MODEL	REV	CHANGE LIST	Model	CT3/5 MB BOARD	
			Page	FROM	TO
CT3/5 MB 31CT3MB0015 31CT3MB0031	1A	PAGE 2 --- Enable CLK48M from cloc k generator for the PLL circuit of 7411, and disable the ocsillator circuit of PCI7411 PLL. PAGE 3 --- Remove H/W shutdown circuit that supported ADM1032. PAGE 4 --- Use X7R type to replace Y5V type for CPU Decoupling/Bypass capacitor. PAGE 10 --- Add a terminal resistor R706 for -CODE_RST# to improve signal quality. PAGE 11 --- 1. Add a 10K pull-up resistor on MCH_SYNC# for booting. 2. Change the power plane of PCIE_WAKE# from 3VSUS to 3V_S5 to solve system can't turn off issue. 3. Change the power plane of ICH_THRM# and SCI_# from 3VSUS to +3V to reduce leakage. PAGE 12 --- We can also use 5VSUS to instead of 5V_S5 to save cost of MOSFET(A06402). PAGE 15 --- Add a level-shift cicuit for EDID interface. PAGE 17 --- 1. Add a off-page and a EMI solution for CLK48M. 2. Remove the reserve resistors (R693~R695) of parallel interface for PCI1510. PAGE 18 --- Remove R696, connect controller and power switch directly . PAGE 19 --- Change R682&R683 value from 56 ohms to 0 ohm cause of BOM error at A-test. PAGE 22 --- 1. Change MC3 type from Y5V to X7R to improv

CARD POWER CONTROL

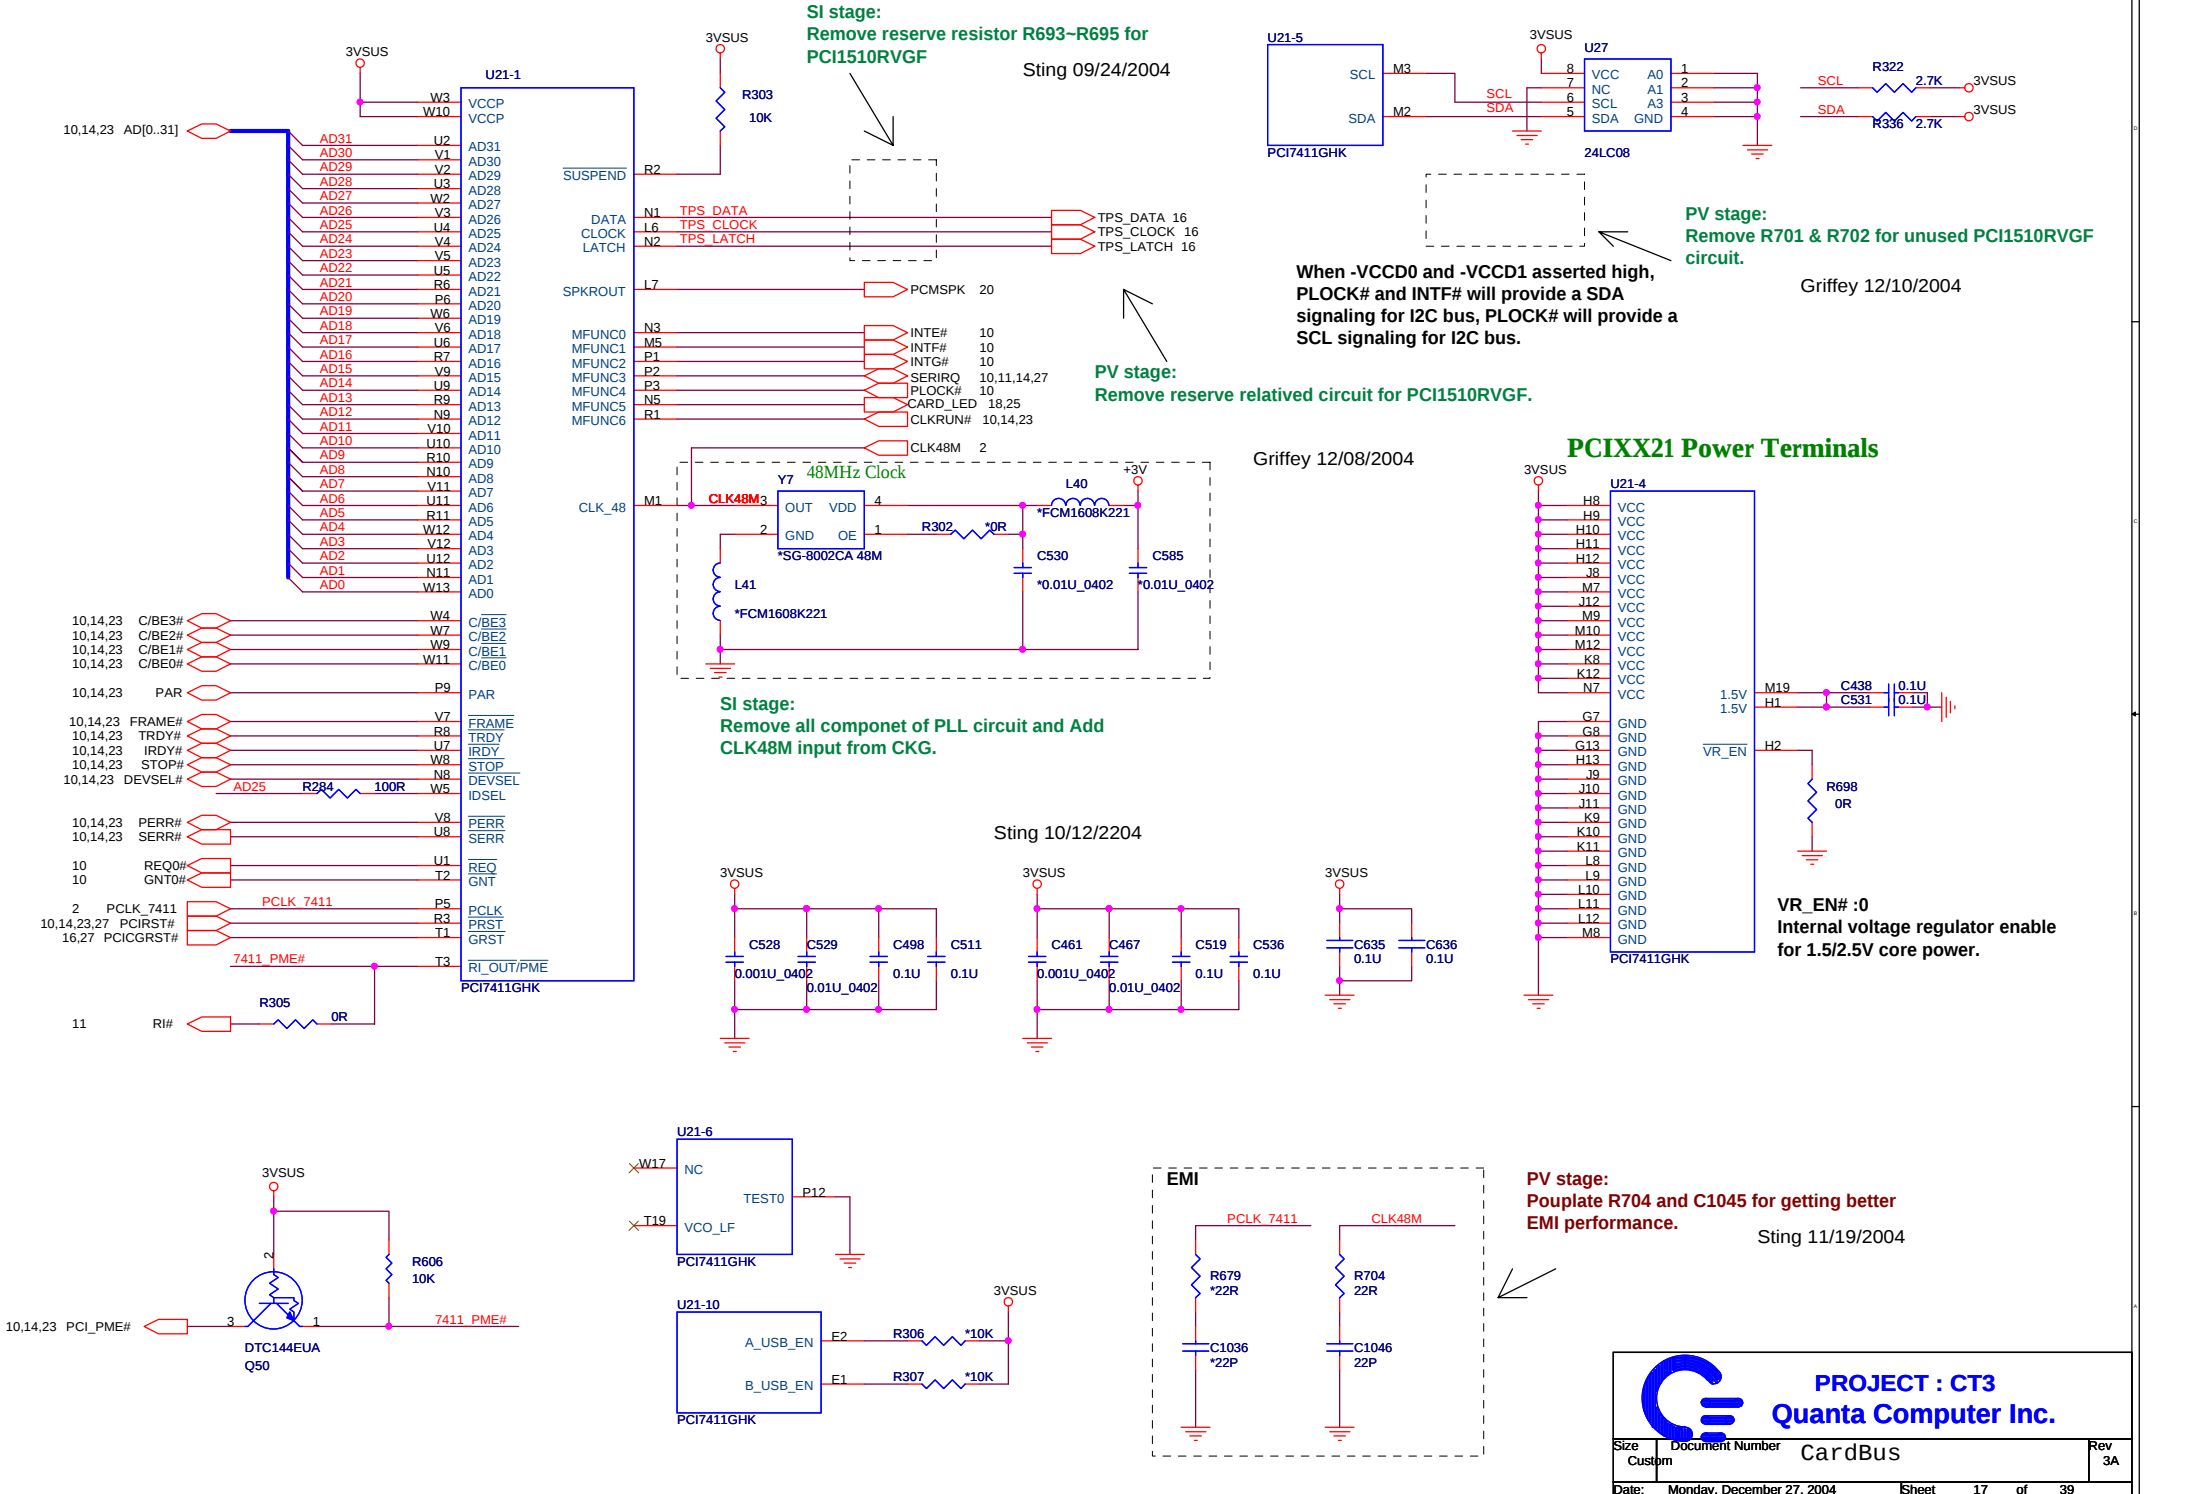
PV stage:
Remove reserve related circuit for
PC1510RVGF.
Griffey 12/08/2004

SI stage:
Remove reserve resistor R696 fro
PC1510RVGF.
Sting 10/12/2004

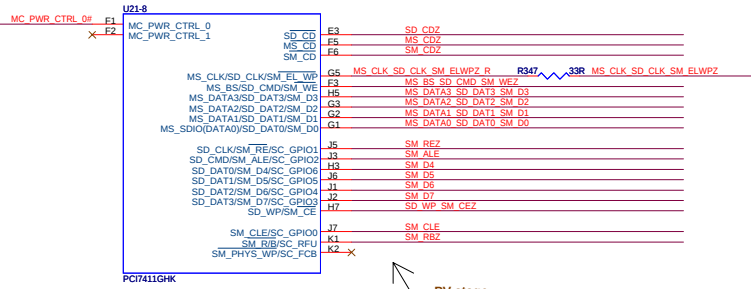
PV stage:
Add a discharge circuit for media
card power.
Sting 11/19/2004

IEEE 1394 CONNECTOR

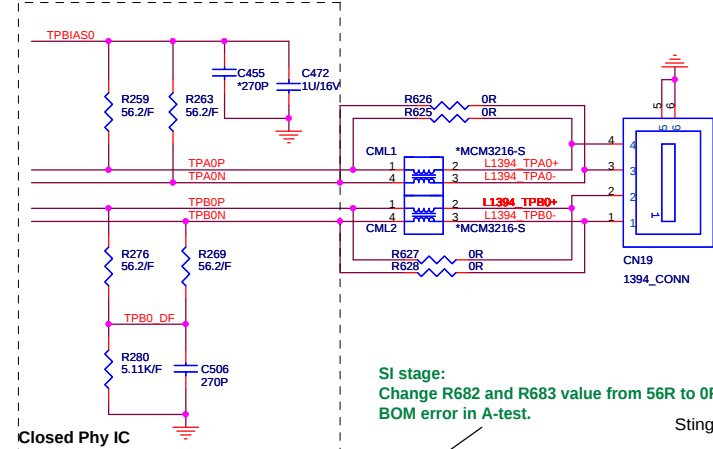
SI stage:
Change R682 and R683 value from 56R to 0R cause of
BOM error in A-test.

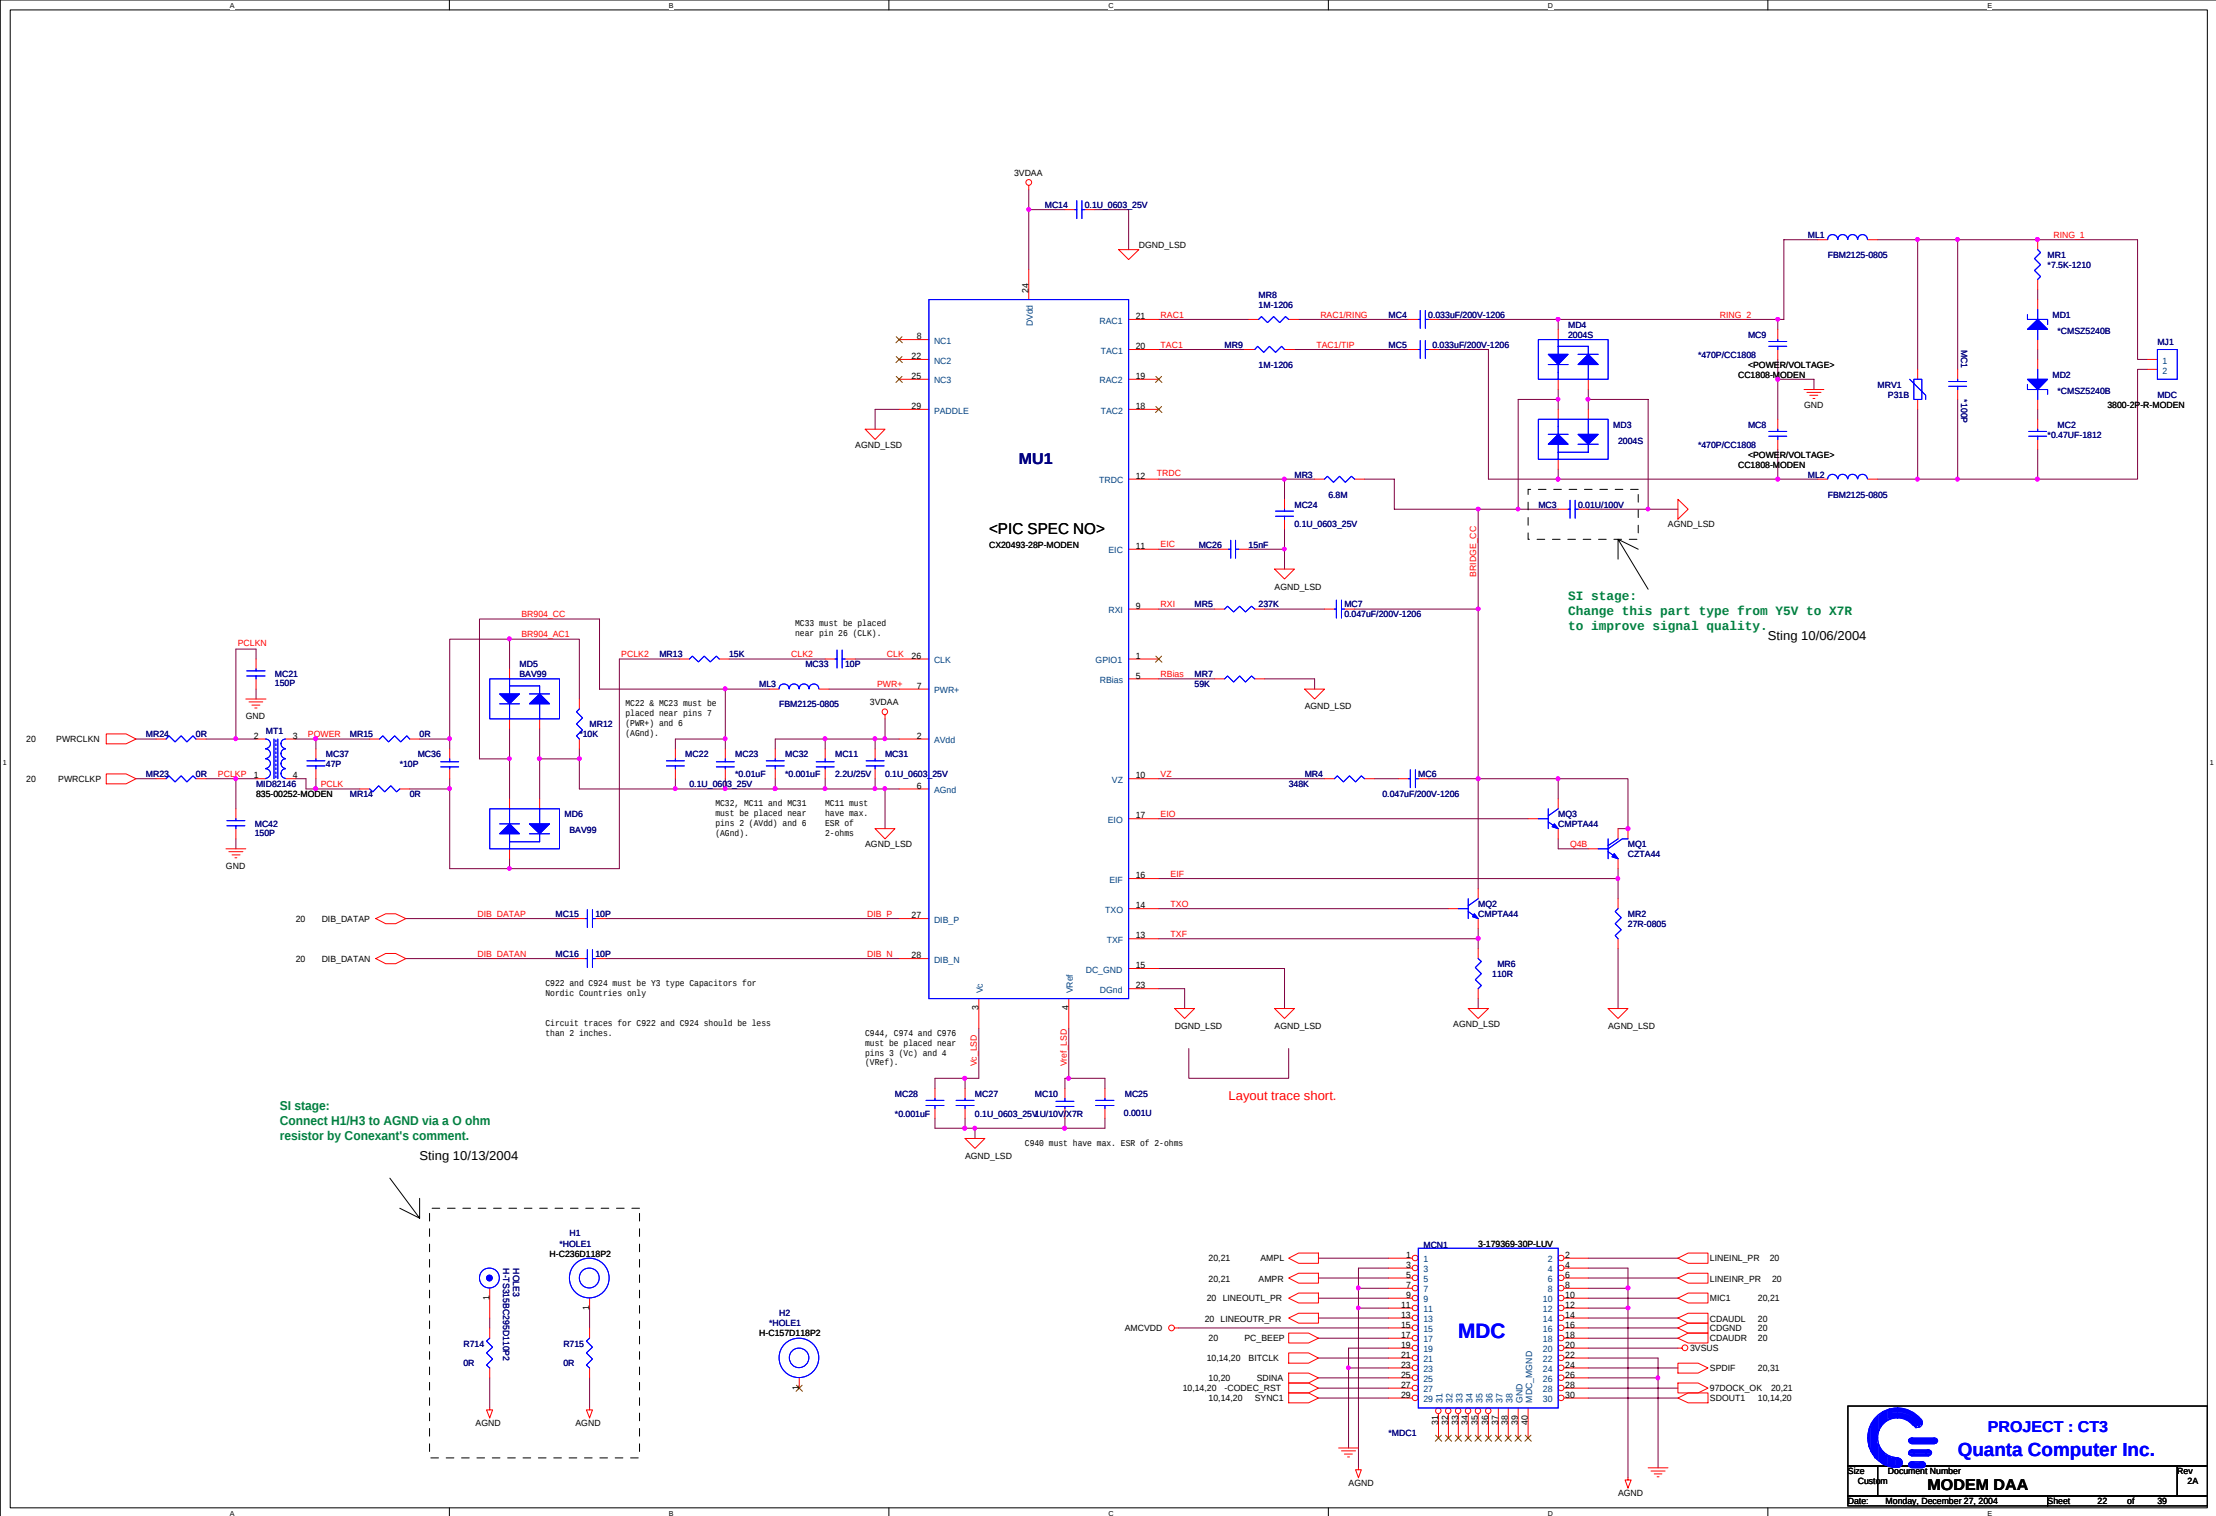
SI stage:
Modified transformer circuit for 10/100M application.

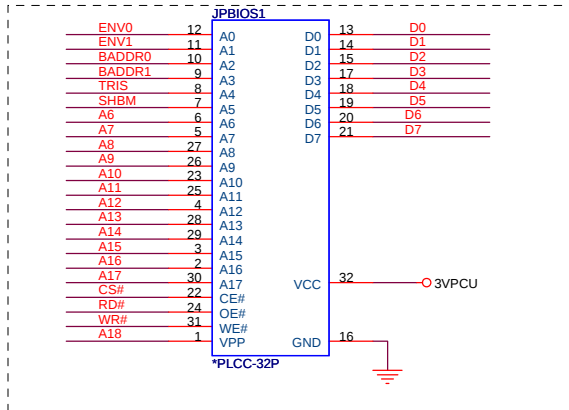
SI stage:
Add PLCC32 cause of it is convenient for Bios debugging.
Sting 10/01/2004

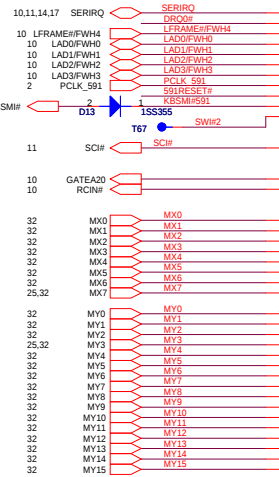
SI stage:
Change R352 value from 120K to 20M.
Sting 09/24/2004

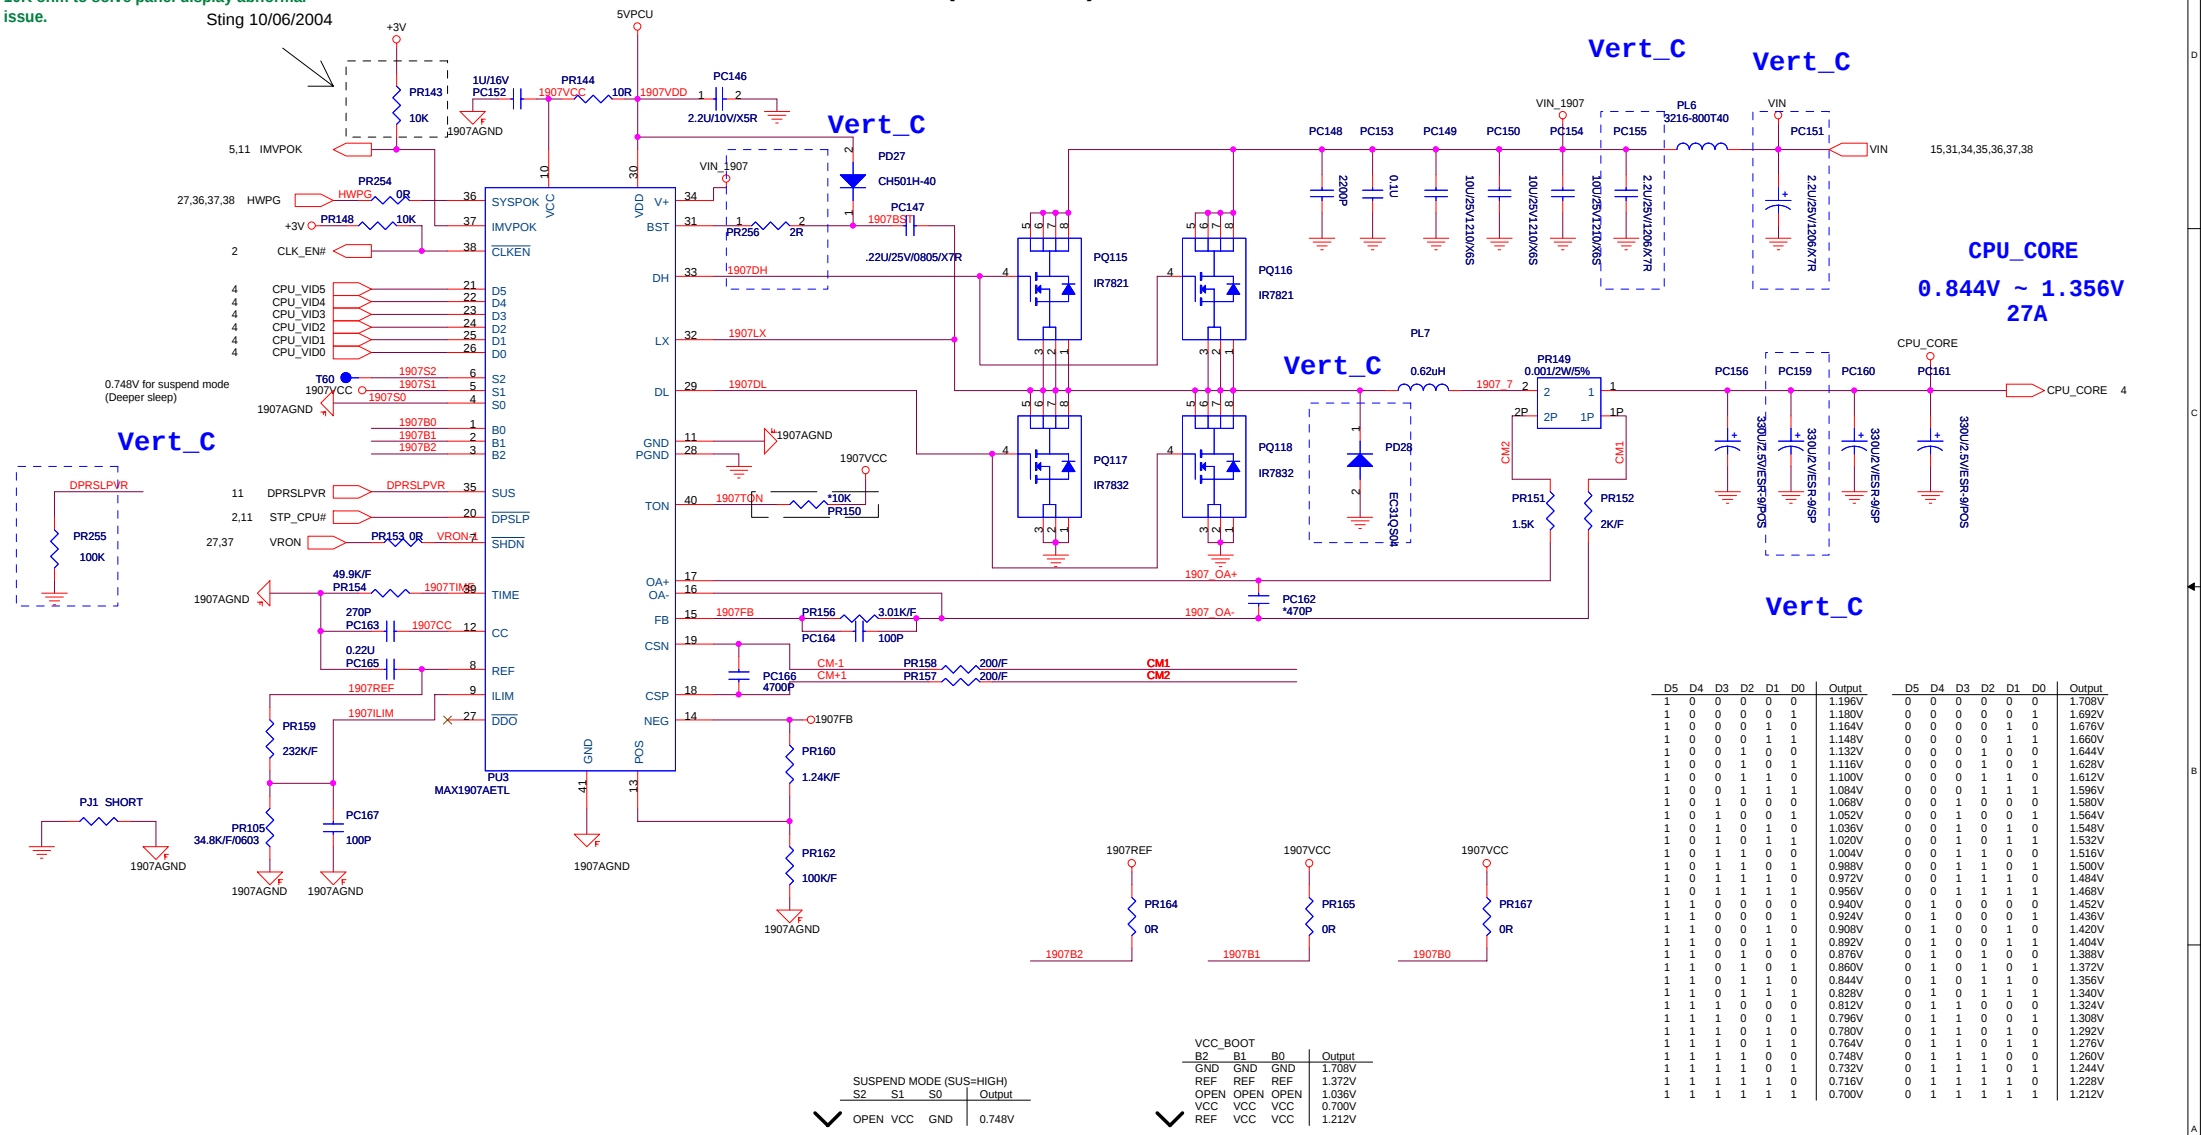
SI stage:
Change PR143 value from 100K ohms to
10K ohm to solve panel display abnormal
issue.

Size	Document Number	Rev
Custom		2A
DISCHARGE		
Date:	Monday, December 27, 2004	Sheet 35 of 39

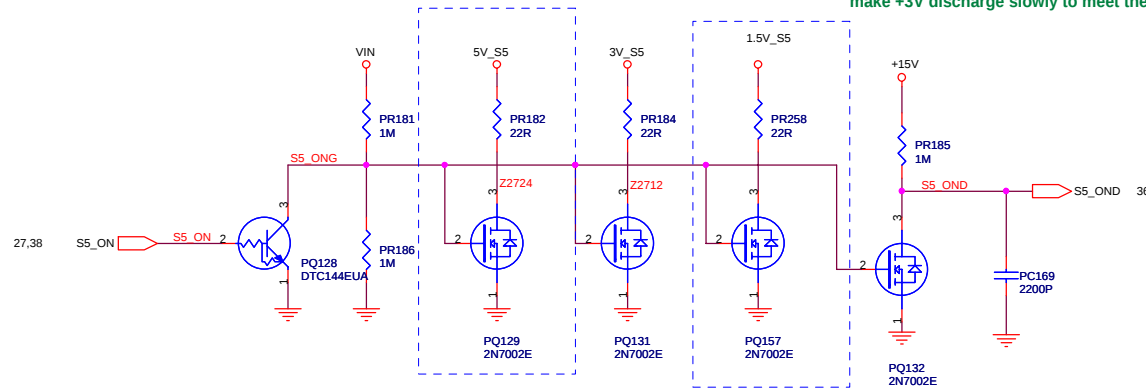
SI stage:
Change PR178 value from 22 ohm to 47 ohm, Intel has required the timing sequence of +1.5V and +3V in the system, we'd like to increase the value to make +3V discharge slowly to meet the specification of falling time.
